CCW IMPOUNDMENTS INSPECTION REPORT

**BRUCE MANSFIELD POWER
PLANT
BEAVER COUNTY,
PENNSYLVANIA**

**PROJECT NO. 09-4157
DECEMBER 2009**

PENNSYLVANIA POWER COMPANY
 BRUCE MANSFIELD PLANT HDS and LDS PONDS
 DIKE STABILITY - DRY CASE

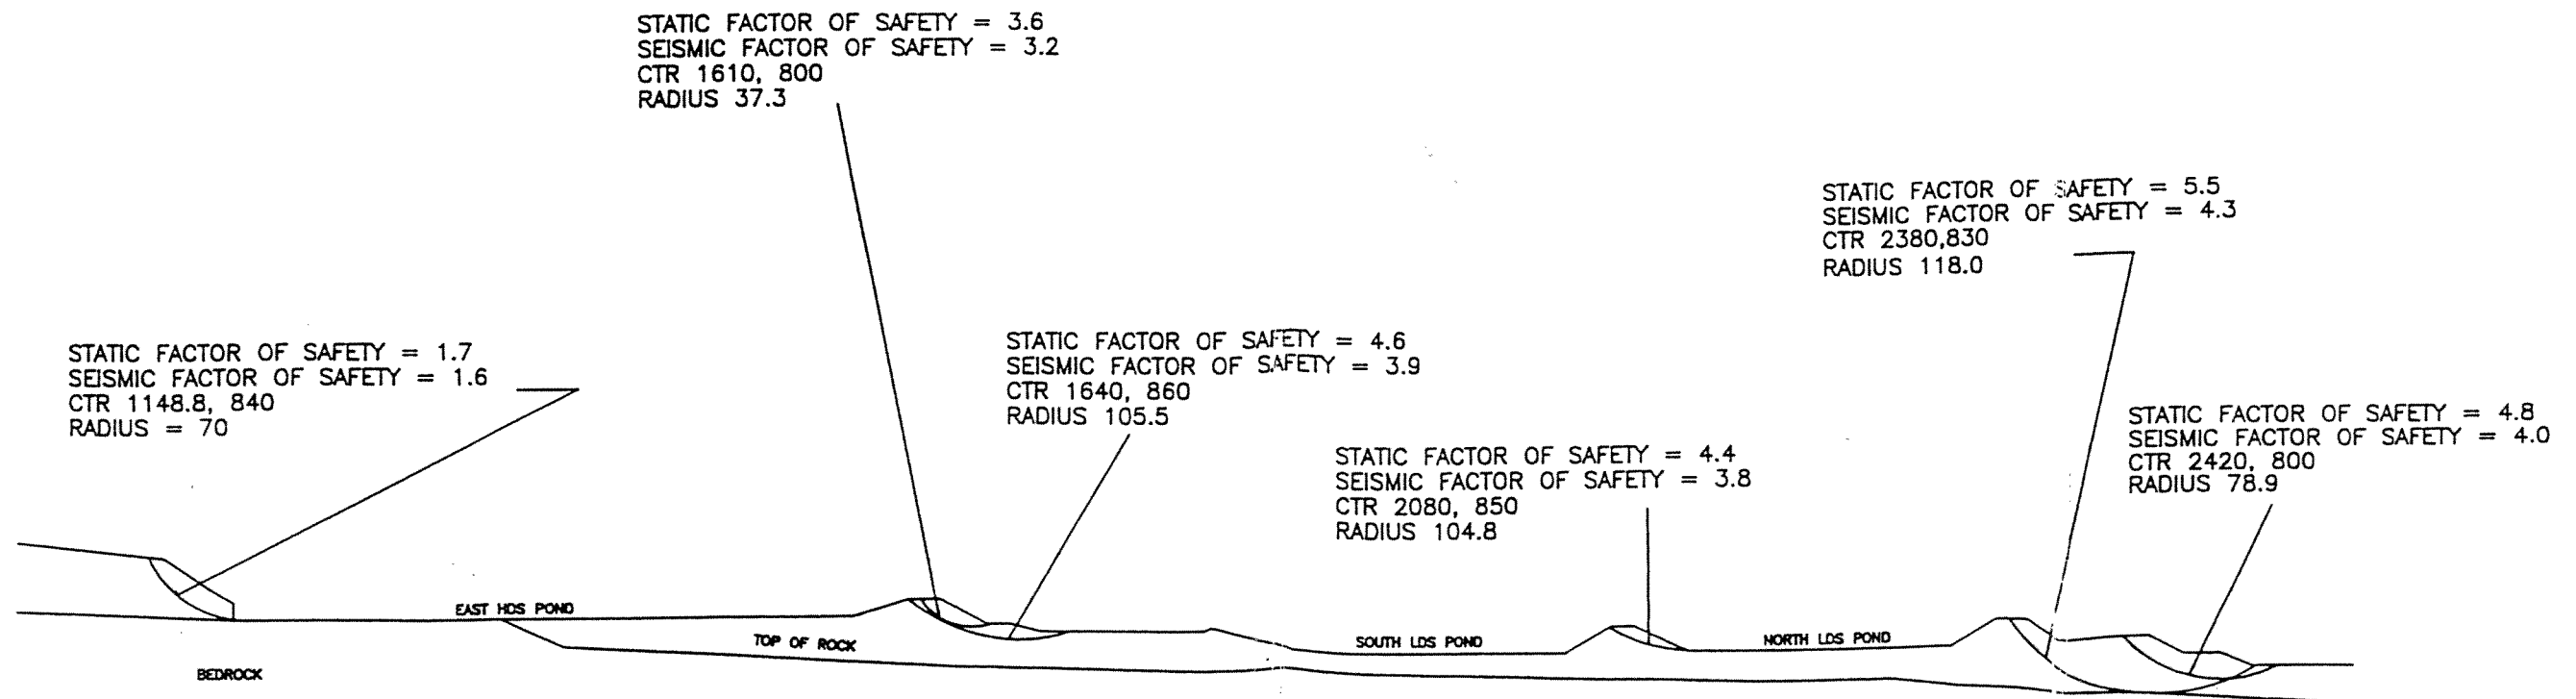
The stability of the embankments for each management unit was analyzed as described in *Section 2.4.2* of this report. The resulting factors of safety exceed the requirements for all load cases. However, it is not clear how the soil parameters were selected since there is no subsurface information and/or laboratory testing data for the soils at the location of the management units. We expect that the engineering documentation for the power plant includes geotechnical information for the entire Site, and that this information was likely used to select the soil strength parameters. Our review of available published geologic information for the Site suggests that the site soils likely consisted of sands and gravels. This is consistent with the use of an asphalt liner placed on the upstream slope to control seepage. On the other hand, the use of a friction angle of 30° and a cohesion value of 500 pounds per square foot for the soil shear strength suggests that a cohesive soil consisting of low plasticity clay may have been used to construct the embankments. The shear strength of a soil consisting of sand and gravel soil would be characterized by a friction angles varying from 30 to 38° and no cohesion. Considering the adequate structural performance of the embankments over the last 34 years, we conclude that the embankments have an adequate factor of safety against slope stability. This is consistent with the evaluation performed by PADEP. However, given the uncertainty with the subsurface conditions and associated shear strength parameters, the factors of safety reported in *Section 2.4.2* may be overestimated.
